ADDENDUM NO. 1

The contract documents for the *Ozarks Electric 1st Floor Remodel* – FOR CONSTRUCTION PKG, dated 08/21/26 are hereby amended by this Addendum, dated 09/02/26 consisting of sixty six (66) pages.

1 ELECTRICAL POWER PLAN QUADRANT C
1/8" = 1'-0"

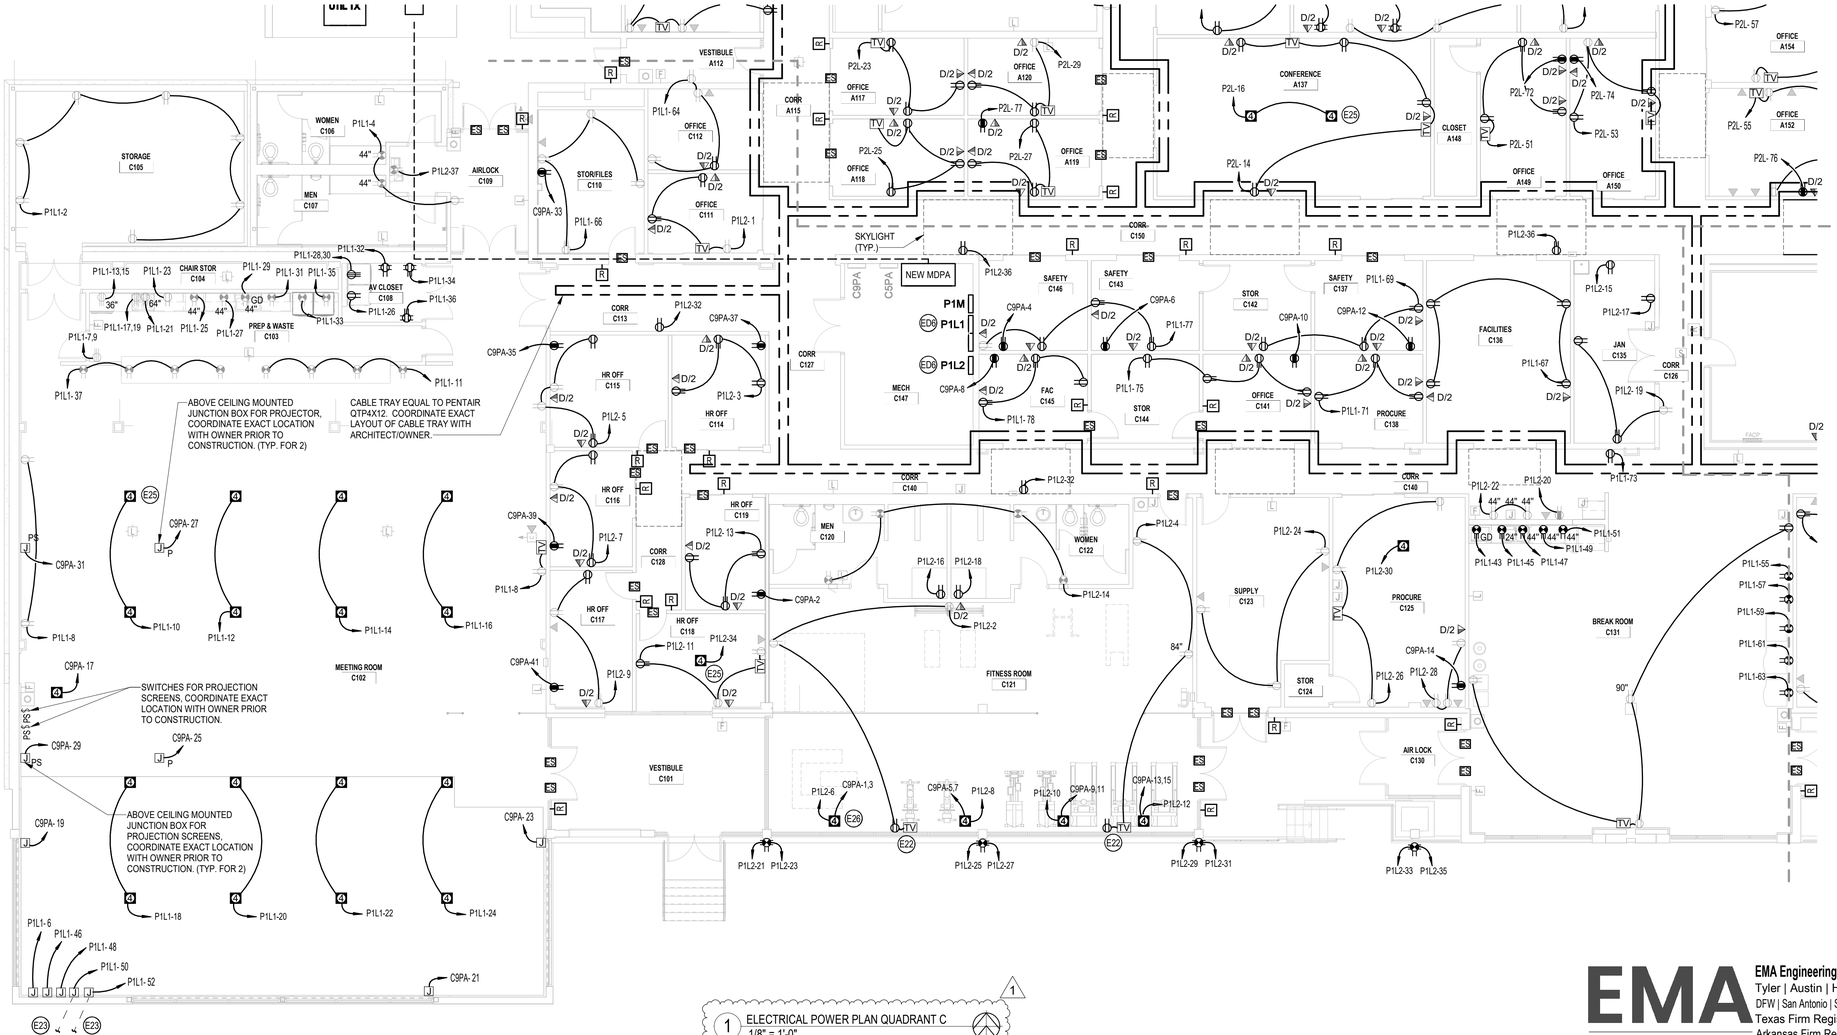
3.5. REFER TO SHEET E101C, ELECTRICAL POWER PLAN, QUADRANT C:

3.5.3. At all TV locations provide a Hubbell netSELECT large capacity AV box equal to catalog number NSAV124M in white color.

3.5.4. Electrical plan note 25 on this sheet shall remove all mention of power poles. Only floor boxes will be installed on this project. Existing floors will be sawcut to install new conduit and floor boxes.

3.5.5. The three windows in room C102 will each have power shades that require an electric circuit. Provide three 20 amp, 1 pole circuit breakers in panel C9PA and route ¾” conduit and #12 wire from the panel to the new shade power sources above the ceiling in room C102.

3.5.6. Provide a 4-gang floor box beneath the podium centered in the room near the west exterior wall. Provide a 20 amp, 1pole breaker in panel C9PA and ¾” conduit and #12 wire from the panel to a duplex receptacle in the floor box.

3.5.7. Two new projectors will be located in the ceiling of Room C102 along the west exterior wall. Refer to the AV drawings for exact location of the projectors. Provide a 20 amp, 1 pole circuit breaker in panel C9PA and route ¾” conduit and #12 wire from the panel to the new projector power sources in the ceiling.

3.5.8. Provide a NEMA 6-20 receptacle in each floor box in room C121 for existing and future treadmills (four total required). Provide four 20 amp, 2 pole breakers in either panel C9PA and ¾” conduit and #12 wire from the panels to the floor boxes.

3.5.9. Move the floor box in room C125 to the north to be centered beneath the conference table. Refer to the furniture plans for exact table dimensions and location.

3.5.11. Note E24 shall be modified as follows: There are approximately 50 existing roof drains on this building. Provide heat trace at each roof drain below the roof level for the first ten feet of piping from the roof drain. Mount the heat trace to the bottom of the drain piping. Connect all roof drains to power at 120 volt as follows. Up to 25 roof drains can be connected to a single 20 amp, 1 pole circuit breaker. All roof drains in Area C shall connect to power at circuit P1L1-54 as presently designed. Relocate the circuit P1L1-56 to quadrant A to serve all roof drains in that quadrant. All roof drains are shown on revised sheet E301A. Heat trace shall be equal to Raychem HWAT-R2 self-regulating temperature maintenance heat tracing cables with RayClic cable connection kits, and GT-66 filament tape wrapped around the cable at 12” centers along the pipe. Provide one

model C910-485 programmable single circuit controller per 20 amp circuit (4 total required). Refer to sheet E-102 for existing roof drain locations.

3.5.12. Delete heat trace circuits P1L1-58 and P1L1-60 from this quadrant. See new circuits described for quadrant B and D in this addendum.

1 ELECTRICAL POWER PLAN QUADRANT D
1/8" = 1'-0"

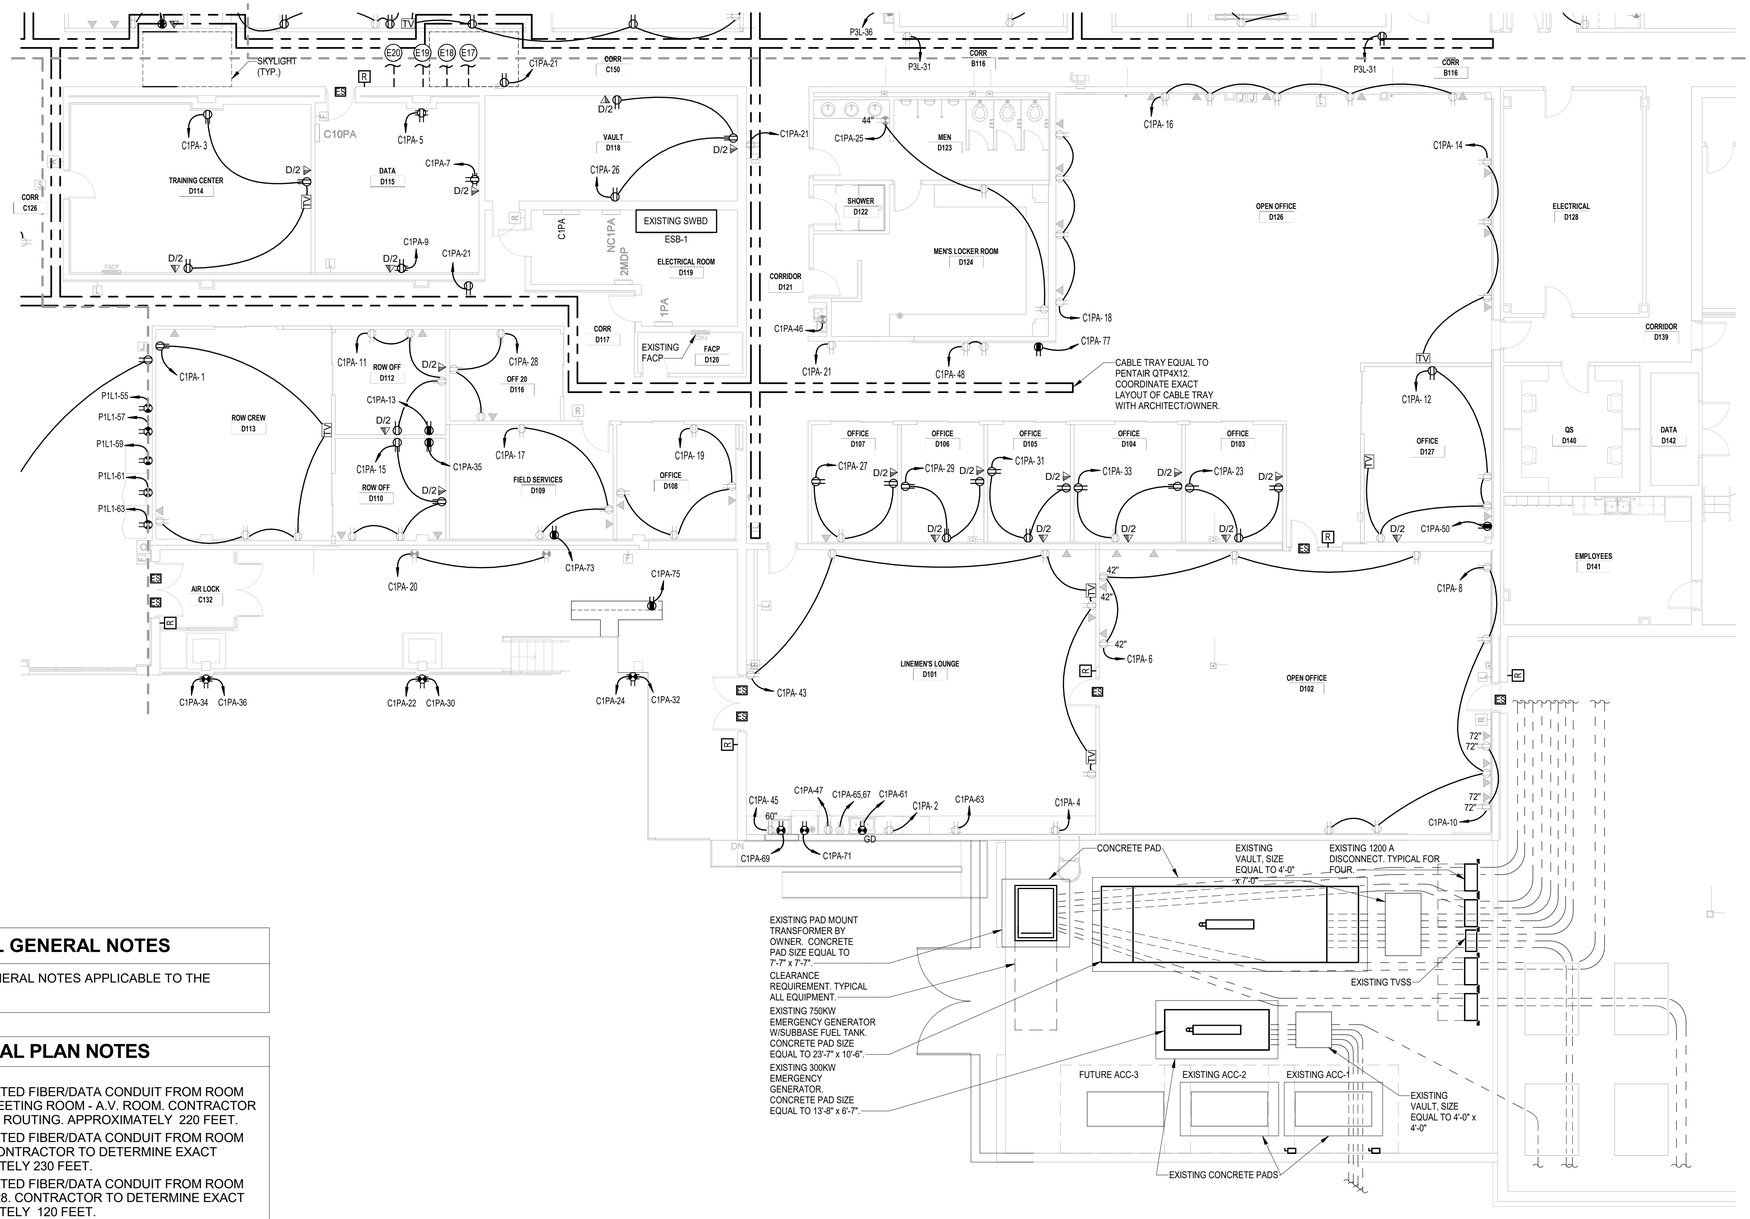
3.6. REFER TO SHEET E101D, ELECTRICAL POWER PLAN, QUADRANT D:

3.6.1. At all TV locations provide a Hubbell netSELECT large capacity AV box equal to catalog number NSAV124M in white color.

3.6.2. Refer to the revised sheet E101D for new TV locations identified in furniture plans included as part of these contract documents.

3.6.3. Provide a 20 amp, 1 pole circuit breaker in panel P3L-74 for heat trace cables in this quadrant. Provide ¾" conduit and #12 wire from the panel to the heat trace controller and then to each heat trace cable in this quadrant.
